Te Hui o Te Kaunihera ā-Rohe o Heretaunga
Hastings District Council
Hearings Committee Meeting

Private Plan Change 9 - Brookvale East

ITEM	SUBJECT	PAGE
2.	PRIVATE PLAN CHANGE 9 – BROOKVALE EAST, 137-161 BROOKVALE ROAD, HAVELOCK NORTH (METLIFECARE LIMITED) (RMA20230358) (PID 58825)	
	<u>Document 2</u> Containing these attachments	
	Attachment B Summary of Recommendations on Submissions and Further Submissions	Pg 3
	Attachment C Technical Memo - 3 Waters	Pg 19
	Attachment D Technical Memo - Transport	Pg 35

To: Rebecca Hill
From: Kelly Nikora
Date: 17 Dec 2025
Subject: PPC9 – Brookvale East – 3 Waters Infrastructure

Figure 1 : Proposed Brookvale East Development

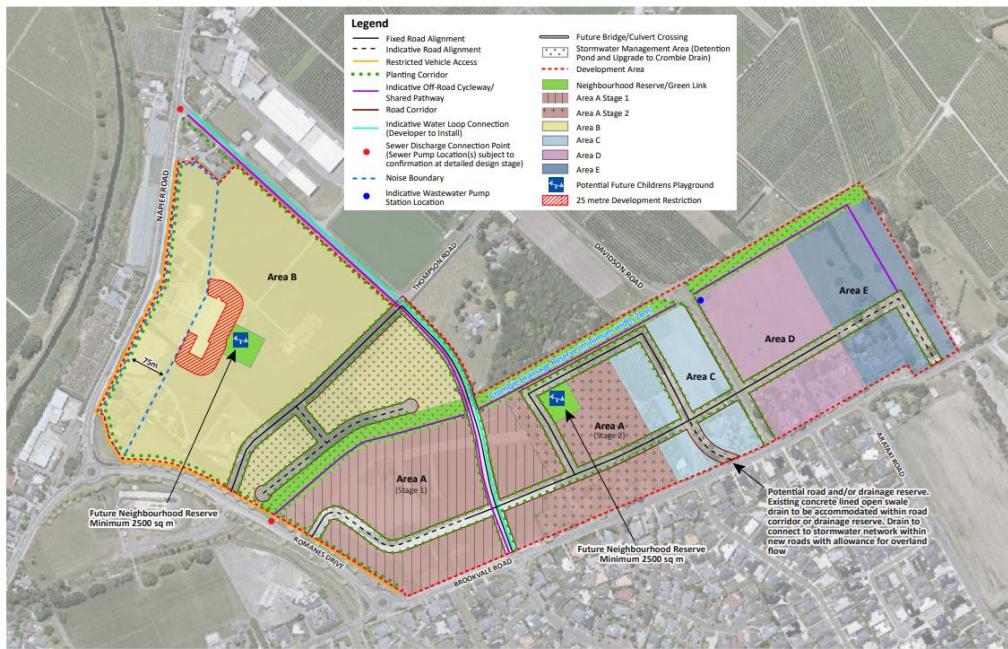
Private Plan Change 9 seeks the extension of the Brookvale Structure Plan area and alteration of the provisions of the Plan, at Appendix 13B of the District Plan. The following components are proposed as illustrated in **Figure 1** below.

It is proposed to extend the structure plan to incorporate land at 137 and 145 Brookvale Road as new “Area D”. This includes the following key components:

- An extension to the proposed Crombie Drain Reserve for stormwater management purposes. The 28m minimum width is continued and is supported by initial stormwater modelling. This land to be zoned Open Space.
- The remainder of Area D to be zoned Havelock North General Residential Zone.
- Continuation of the east-west “spine” road parallel to Brookvale Road (being the extension of Beecroft Drive) from Areas A and C into Areas D and E.

Beyond Area D, the structure plan is proposed to be further extended to provide a “Deferred Residential” zone for the land at 155, 157, 159 and 161 Brookvale Road as new “Area E”. The intention is this area will be able to be developed in accordance with the Havelock North General Residential Zone once infrastructure solutions (including timing and funding) have been agreed with HDC and a Plan Change is undertaken to provide a “live” Residential Zone. Initial assessment has been undertaken to support the inclusion of Area E into the structure plan, with further detail to be provided as part of a future rezoning process.
